A9 Dualling: Kinraig to Dalraddy Stage 3 Cycle/Accessibility Audit

Client:	Wills Bros. John Paul JV Ltd.
Project Title:	A9 Dualling Kinraig to Dalraddy
Document Title:	Stage 3 Cycle/ Accessibility Audit
Document No:	MGT0275RP0022

Problem 3.1 –No Signage Provided to Identify NMU Route

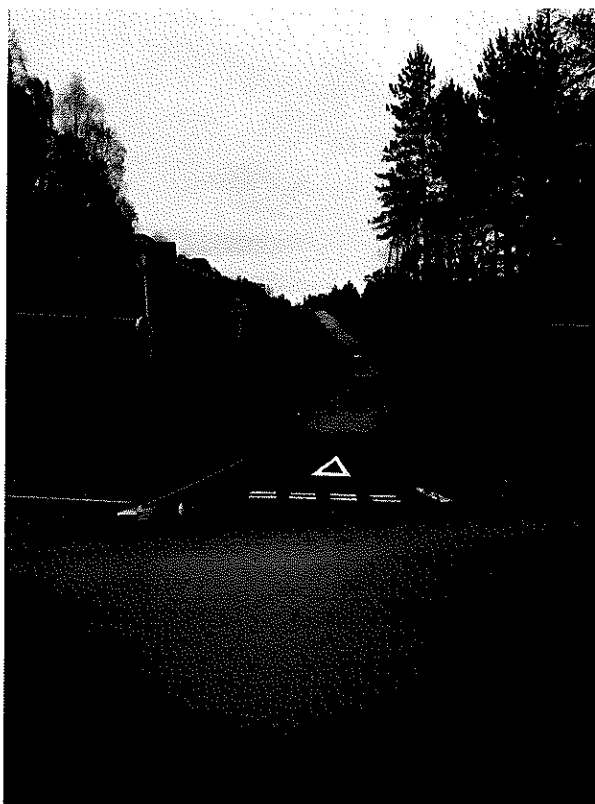
Location: Junction to RZSS Highland Wildlife Park, approx. Ch. 0

Summary: No signage on local road to identify NMU route.

There is no signage to identify the location of the NMU route to people travelling on the Local Road.

Appropriate signage should be provided to identify location of NMU route.

Problem 3.4 – Steel Plates on ST01 Deck (Left) and Wood Plates on Route Surface (Right)

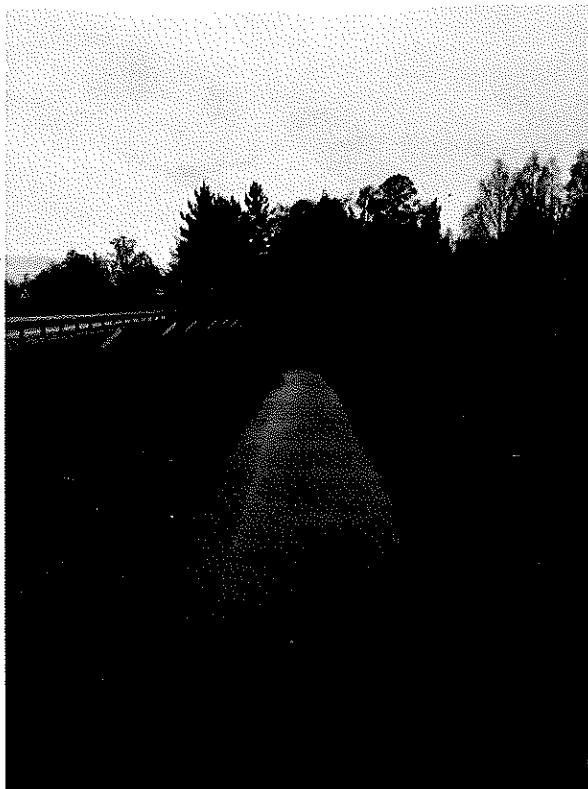
Location: ST01 NMU Bridge, approx. Ch. 30 and Junction at Ch. 2350 approx.

Summary: Steel / Wood Plates on NMU bridge / route surface.

Steel plates located on the deck of ST01 and wood plates on the travel surface at the junction at Ch. 2350 could cause a trip hazard to NMU's.

Steel plates on the deck and wood plates on route surface should be removed.

Problem 3.5 – Cranks on Fencing

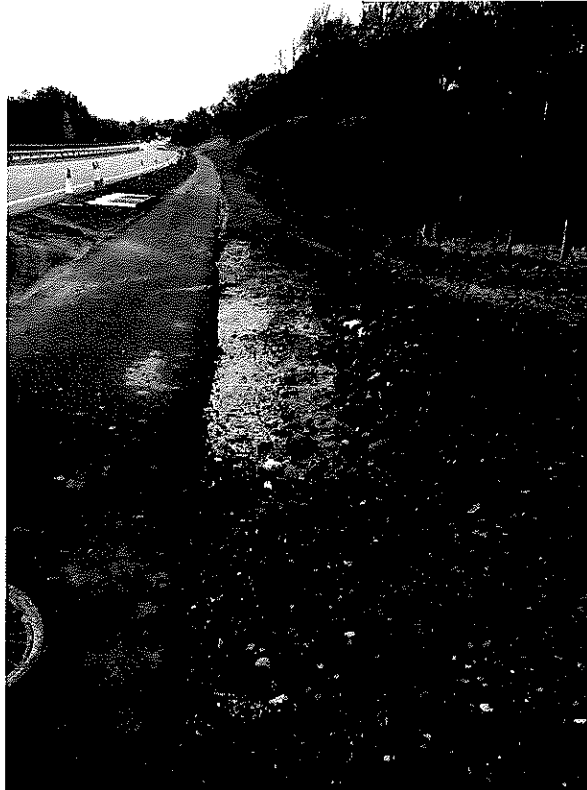
Location: Ch. 0 – Ch. 100

Summary: Cranks on fencing close to NMU track

The cranks on the top of the badger and otter fencing are located approximately 1m from the edge of the NMU route. This could lead to NMU's colliding with the cranks causing injury

Hazard should be mitigated by provision of secondary fence line or bund to prevent NMU's colliding with cranks.

Problem 3.8 – Cracked Surface at Ch. 1060

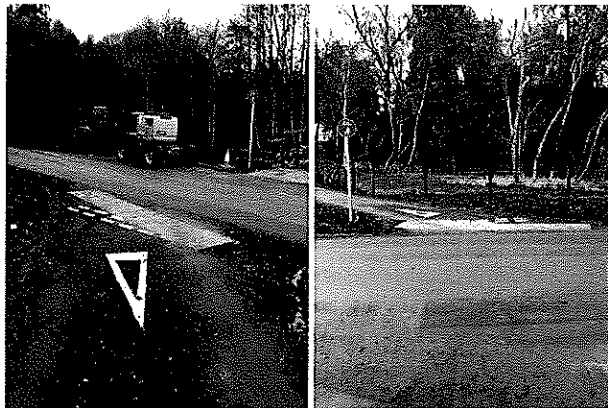
General; cracking of pavement at the edge of the NMU route.

There is a cracking in the NMU track surface at a few locations which appear to be result of vehicle tracking. This may result in falls and injuries due to uneven surfaces

The pavement and verge surfaces should be repaired to ensure no cracking or uneven surfaces exist.

Problem 3.13 – Examples of Mud and Debris on NMU Route

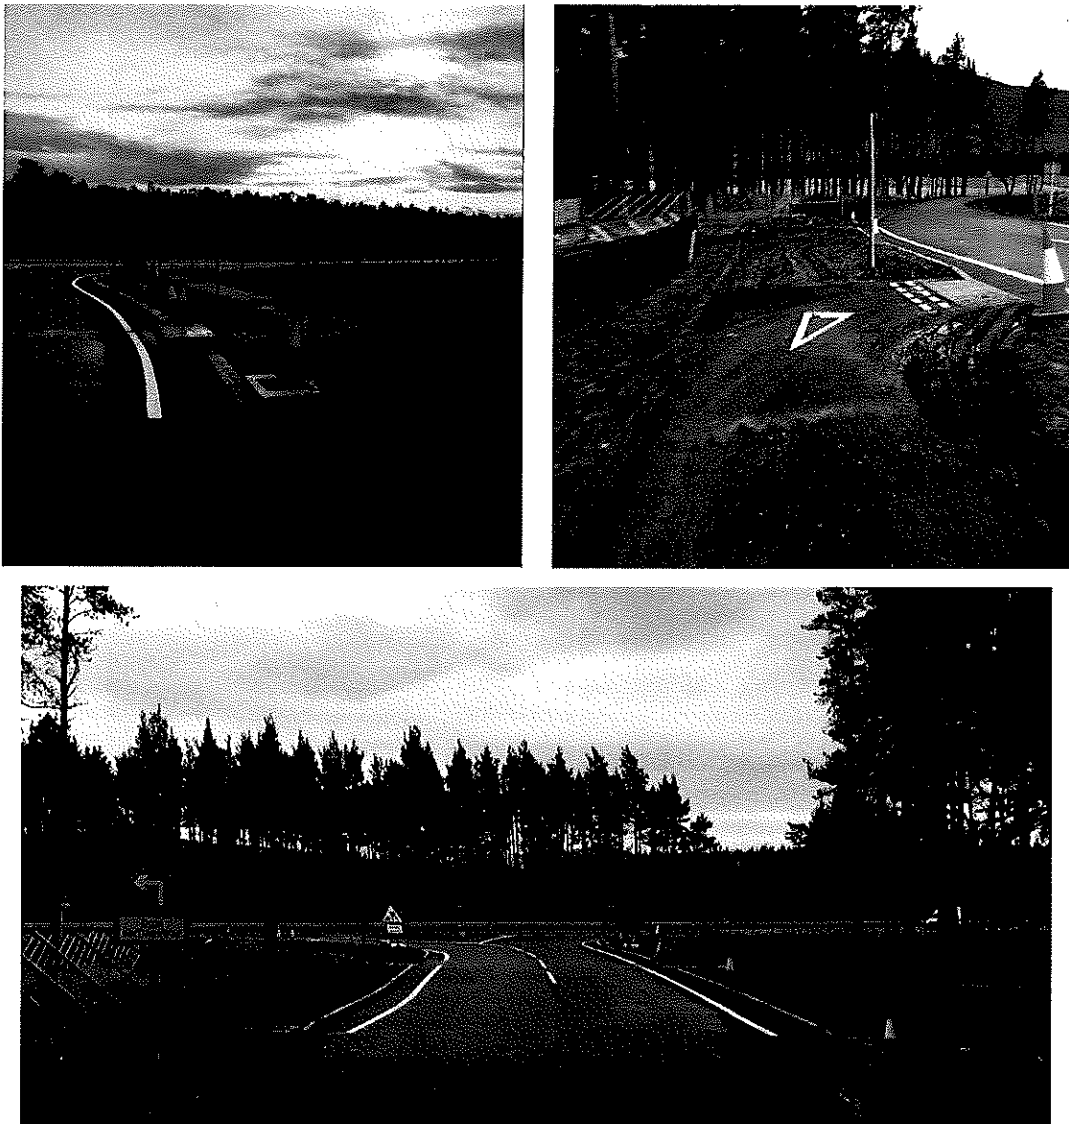
General; mud and debris on NMU surface.

There is mud and debris on the pavement surface at various locations along the NMU route. This can lead to cyclists falling causing injury.

NMU route should be cleaned and all debris removed.
